STAFF REPORT
(One-Step Final Plat)

CASE NUMBER: SUB 2011-27 – MCDONALD’S 3RD ADDITION

LOCATION: East side of Broadway, South of 13th Street North (District VI)

VICINITY MAP

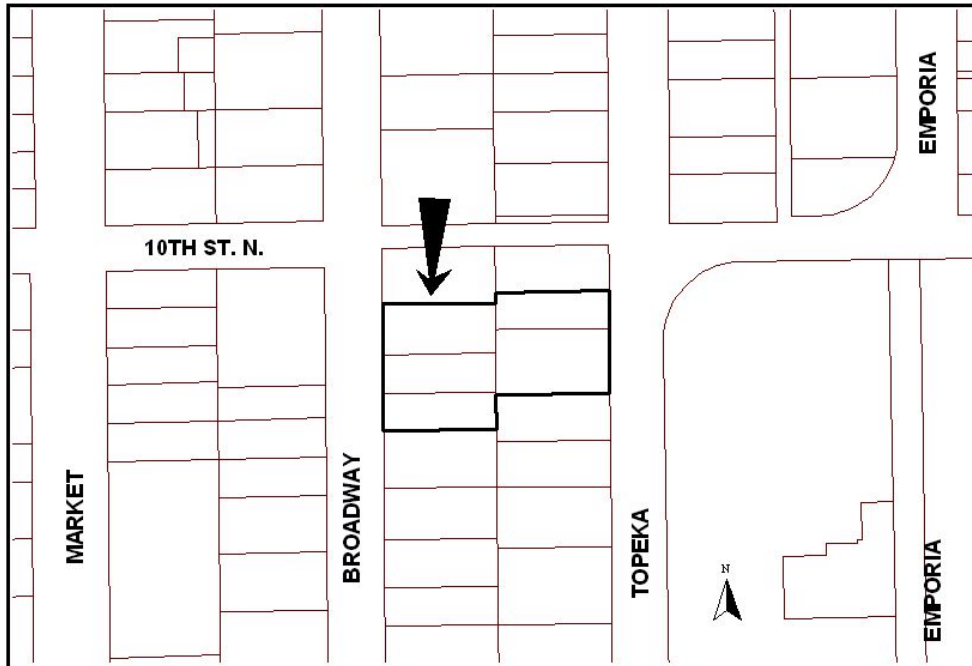
- E. The plat's text shall include reference to "a lot and a block" in the owner's certificate.
- F. The vicinity map needs corrected to show the site between 9th and 10th Street.
